ADDENDUM NO. 5
TO
CITY OF FRESNO
PUBLIC WORKS STANDARD SPECIFICATIONS
ADOPTED MARCH 4, 1970
RESOLUTION NO. 70-36
UPDATED VERSION APPROVED October 15, 2014

This addendum is attached to and made a part of the above-entitled standard specifications.

The following City Standard Drawings have been amended as indicated below:

CITY OF FRESNO P-5

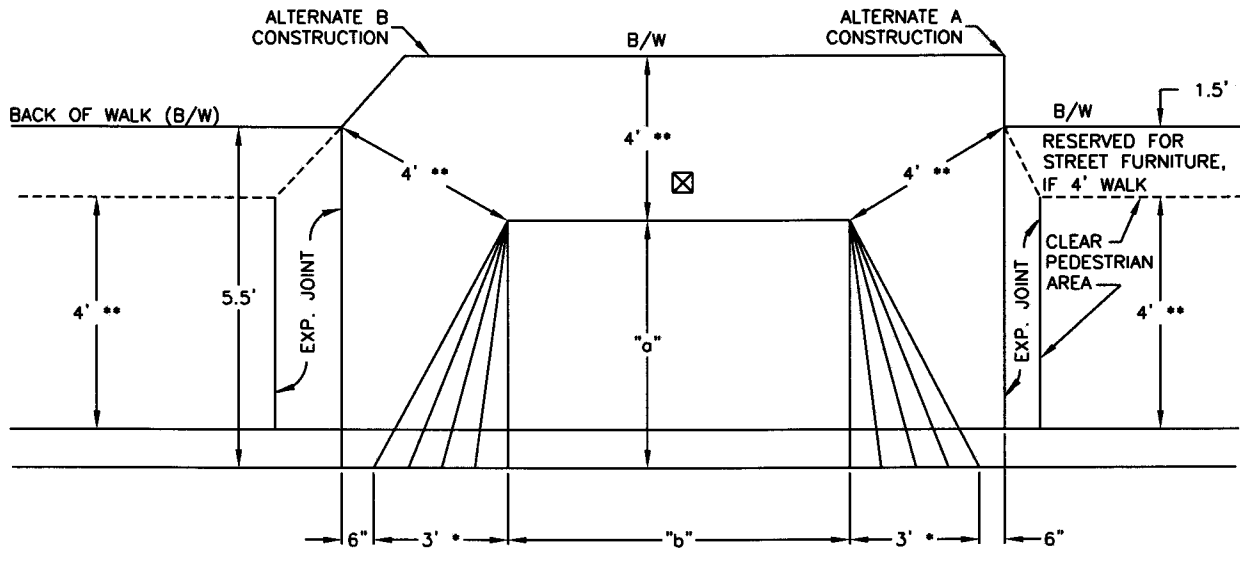
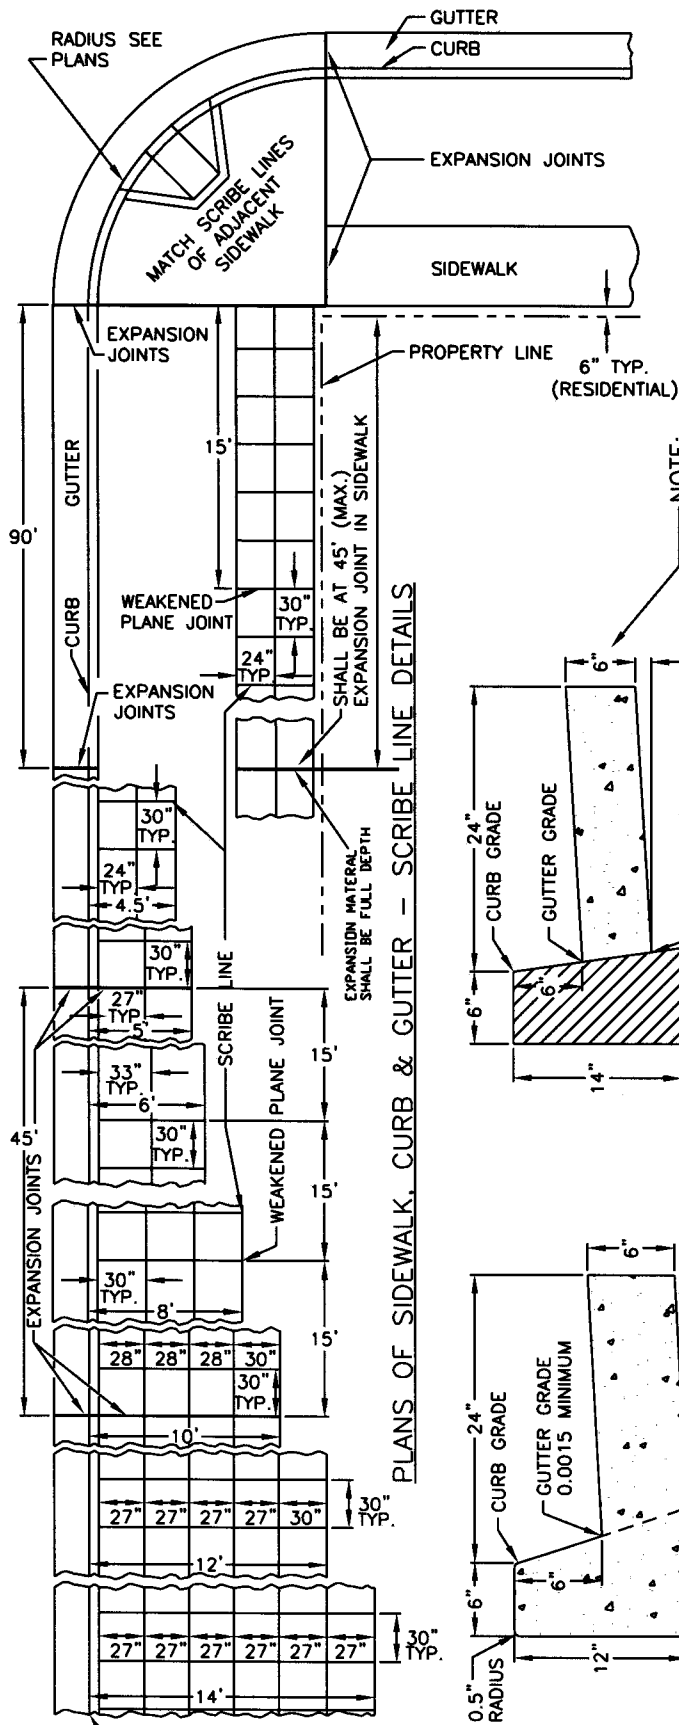
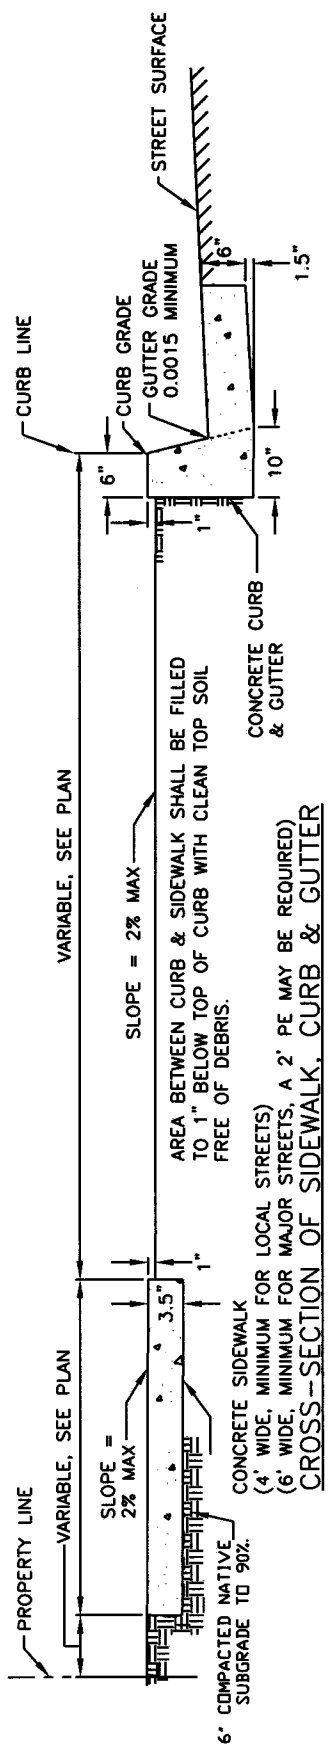
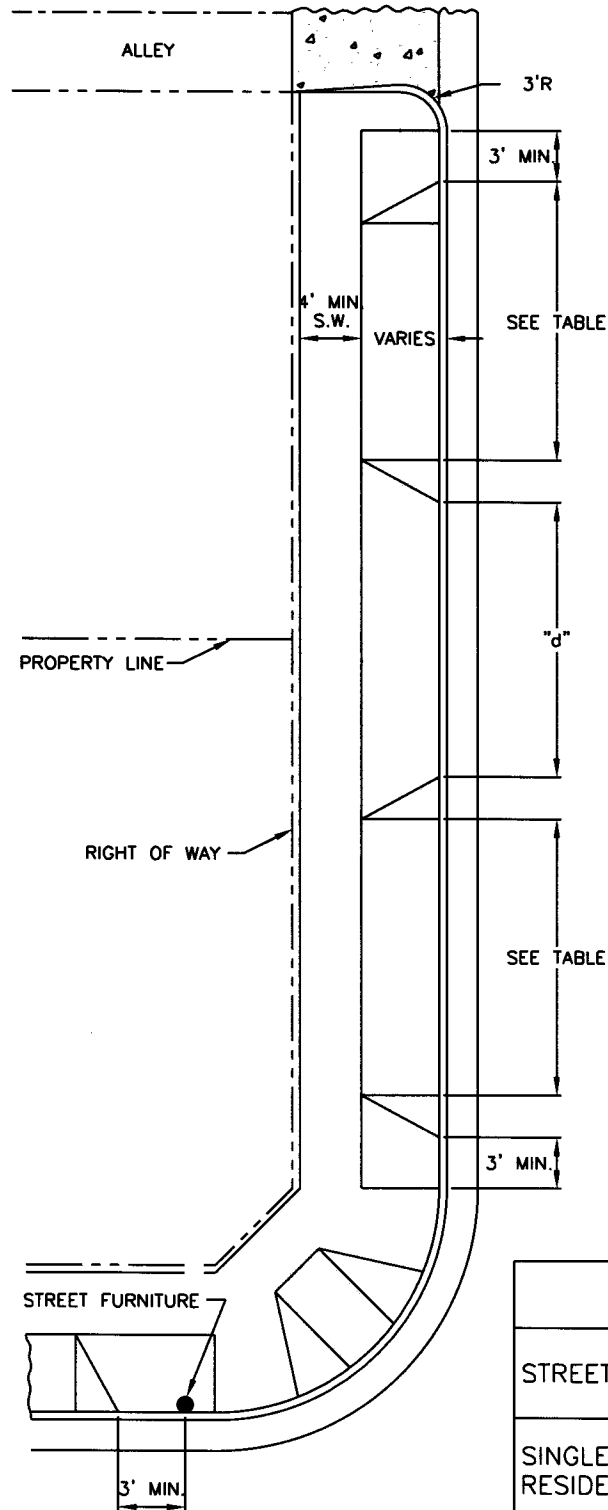
- P-1 Adjusted minimum driveway lengths and pedestrian requirements.
- P-2 Adjusted minimum driveway lengths and pedestrian requirements.
- P-3 Added notes regarding compaction.
- P-4 Added notes regarding compaction.
- P-5 Added notes regarding compaction.
- P-6 Revised and corrected notes.
- P-7 Revised notes and implemented a minimum radius.
- P-9 Provided soil compaction requirements.
- P-10 Corrected notes and added notes regarding compaction.
- P-18 Provided clarity.
- P-28 Corrected dimensions and wheelchair ramp, corrected notes.
- P-29 Corrected dimensions and wheelchair ramp, corrected notes.
- P-30 Corrected dimensions and wheelchair ramp, corrected notes.
- P-41 Added RW (Recycled Water) to this utility location guideline.
- P-42 Added RW (Recycled Water) to this utility location guideline.
- P-50 Added R-value testing requirements. Added notes 9 and 10.

CITY OF FRESNO
P-85

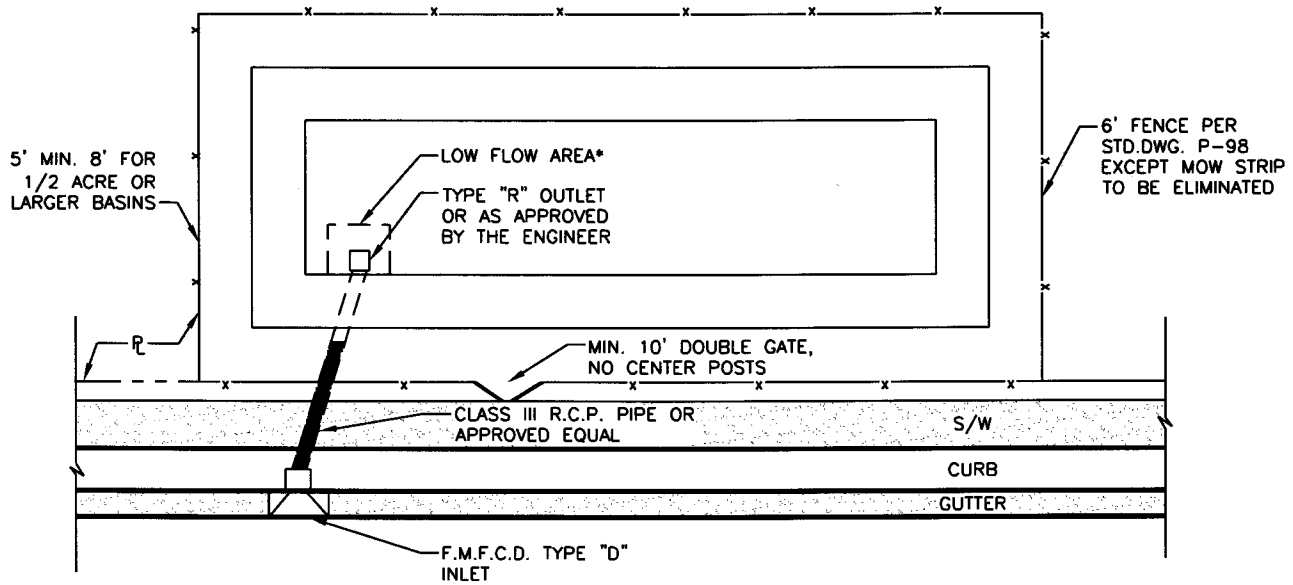
- P-85 Removed bump outs and added soil compaction requirements.
- P-97 Changed dimensions of temporary ponding basins.
- E-1 Added drawing references to notes in lieu of former text, clarified text and drawing details.

E-4B

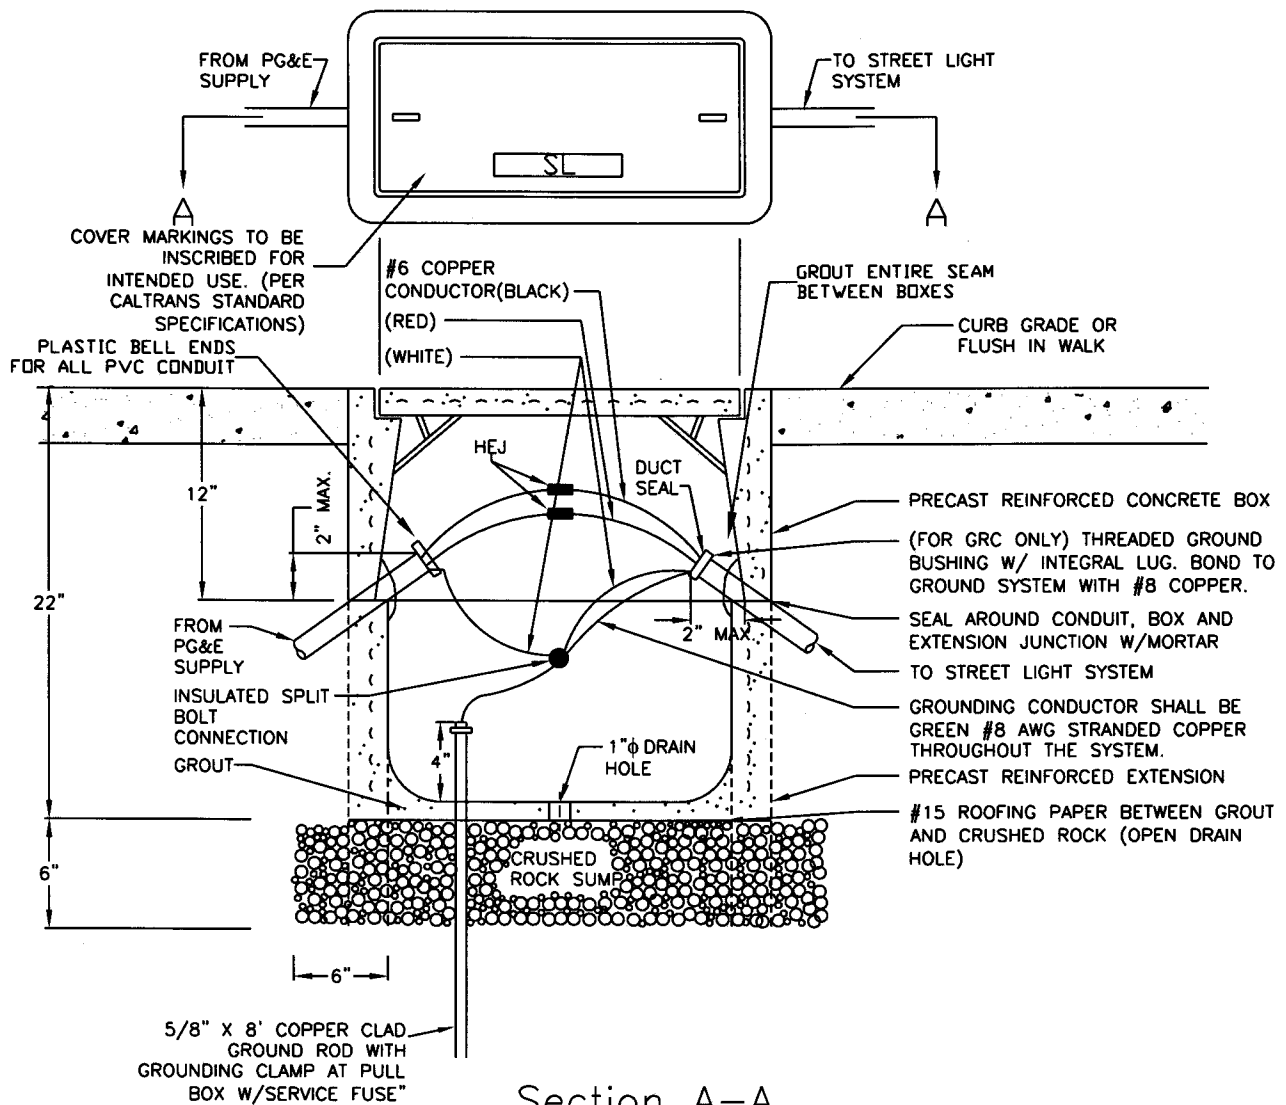
- E-2 Added drawing references to notes, clarified text, changed PVC conduit to NM.
- E-3 Added drawing references to notes, clarified text.
- E-4 Deleted, replaced with new drawings E-4A, E-4B & E-4C.

CITY OF FRESNO
E-4C

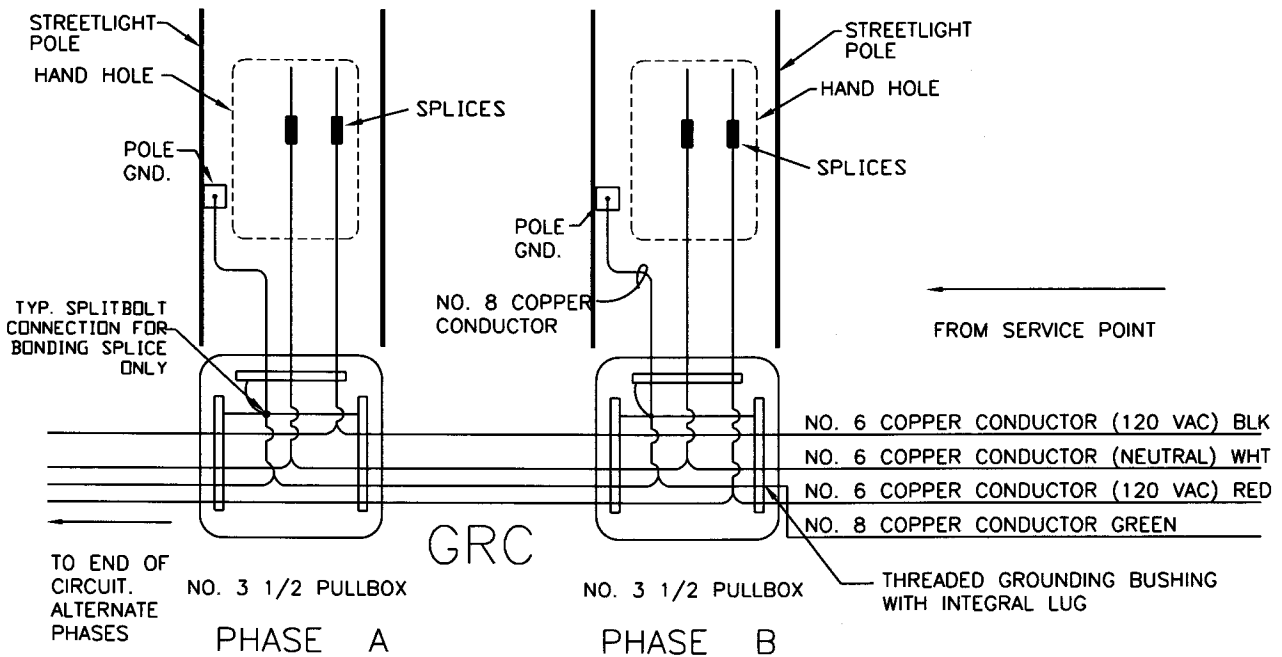
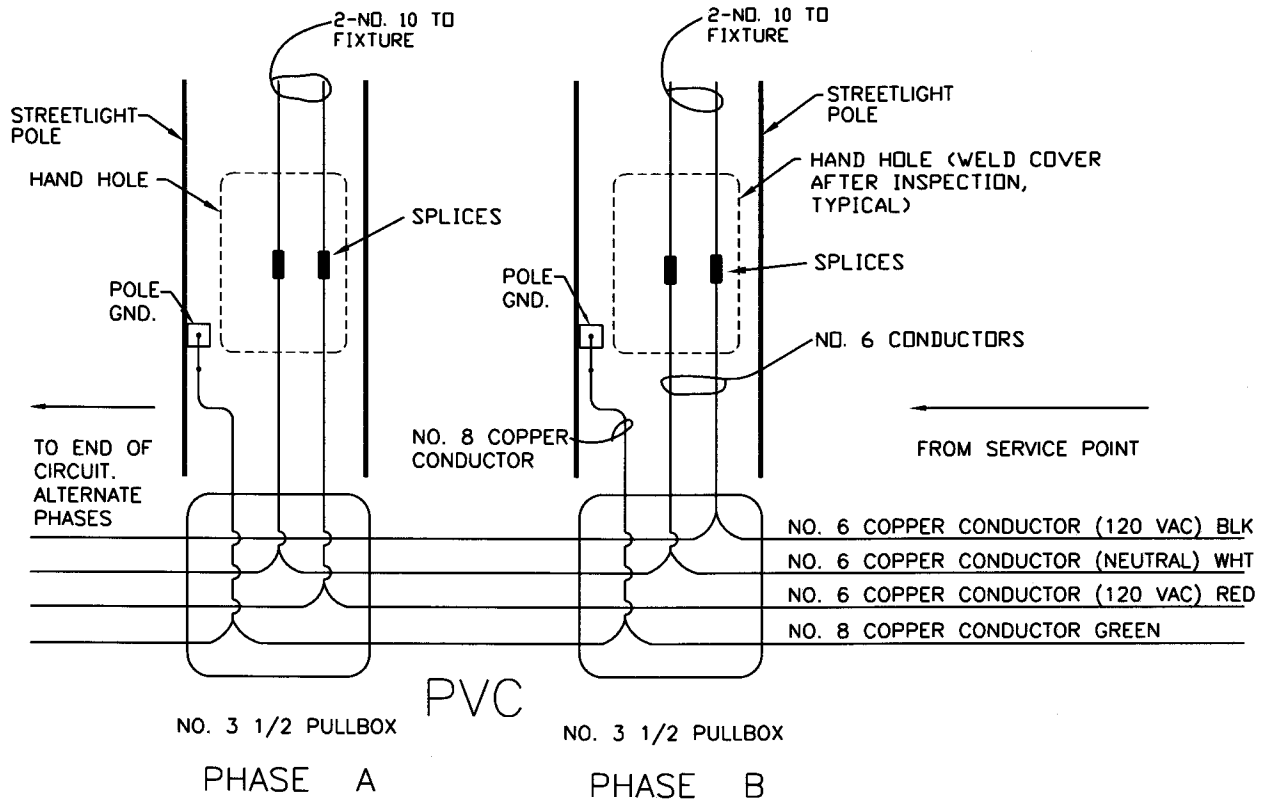
- E-26 Updated part numbers.
- E-27 Modified conduit drawing for clarity.
- E-28 Deleted, replaced with E-4C.
- E-34A Corrected text errors in "Caution" note, changed "752" discriminator to "762".

E-18

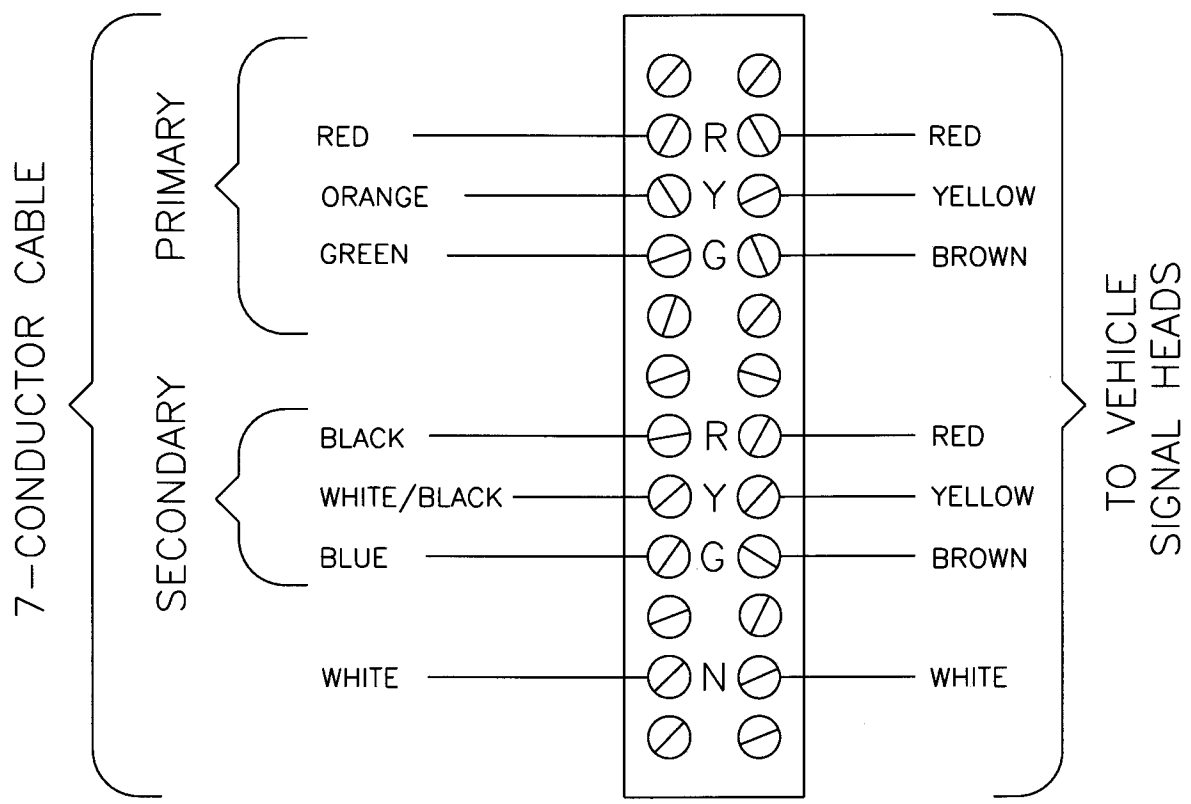
- E-15 Changed 2-pole branch circuit breakers to 1-pole.
- E-17 Added "Note 2", corrected service conduit size.
- E-18 Changed 2-pole branch circuit breakers to 1-pole.

E-37

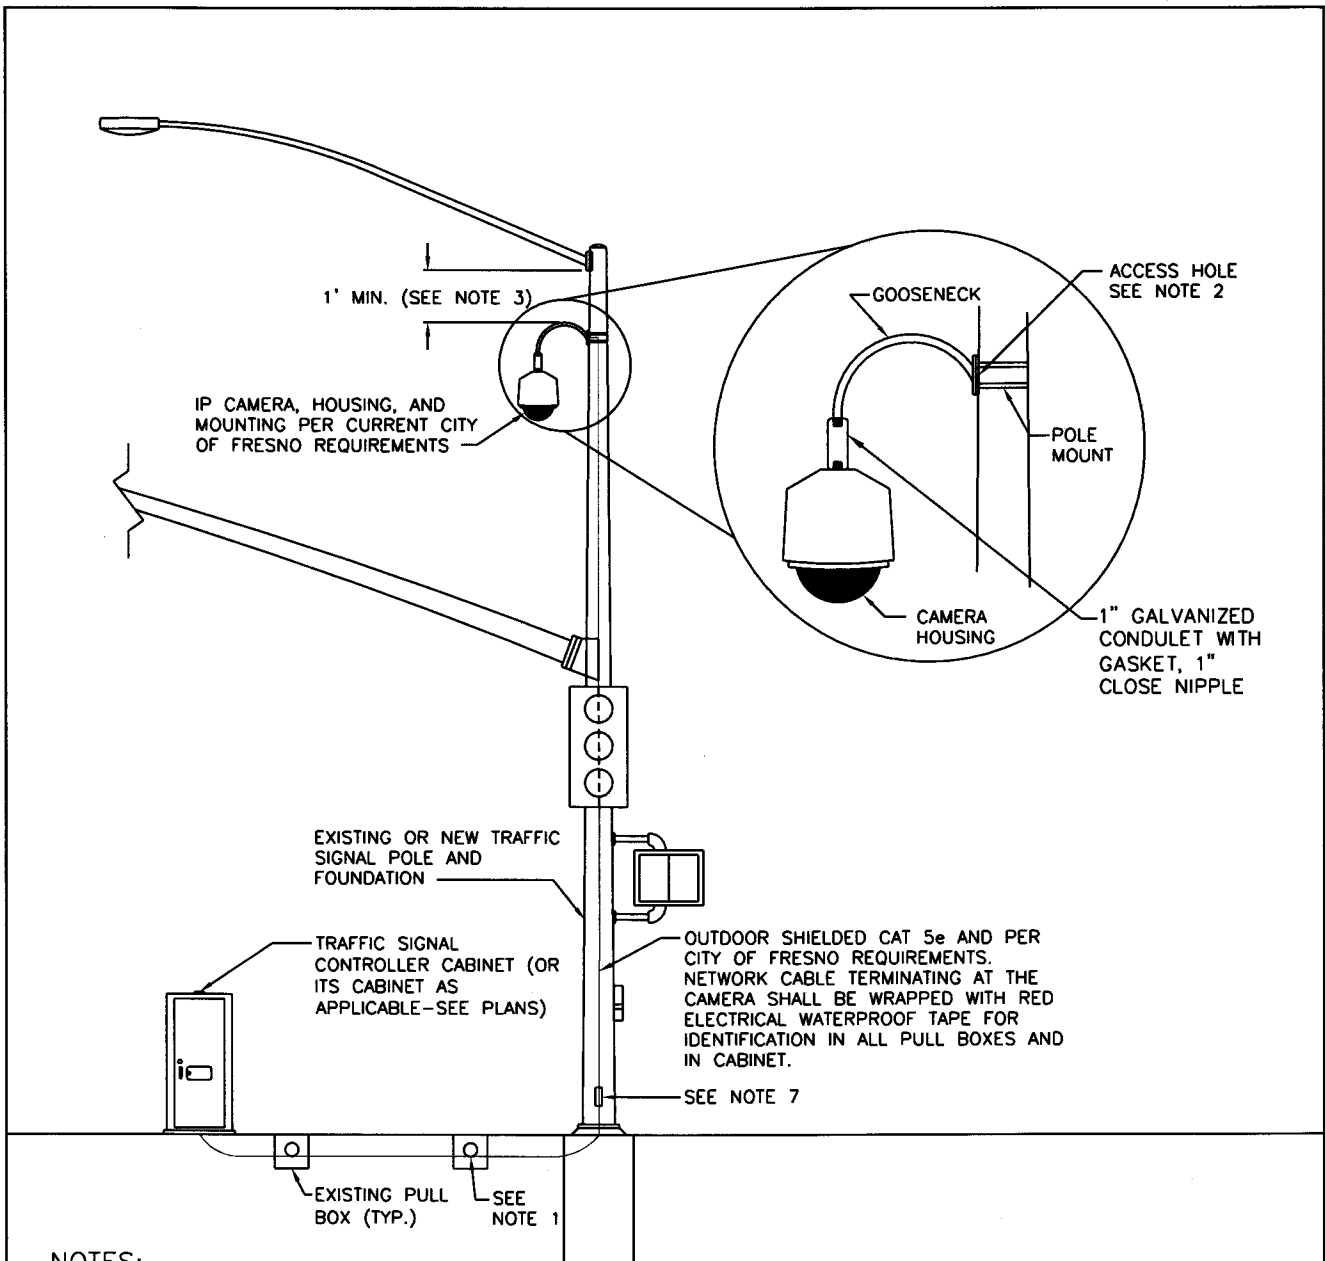
- Paragraph 11: added "as shown in Dwg. E-37"
- 23-1.9 Paragraph 2: Clarified use of PVC conduit.
- Paragraph 6: Clarified bonding bushings shall have integral lay-in lugs
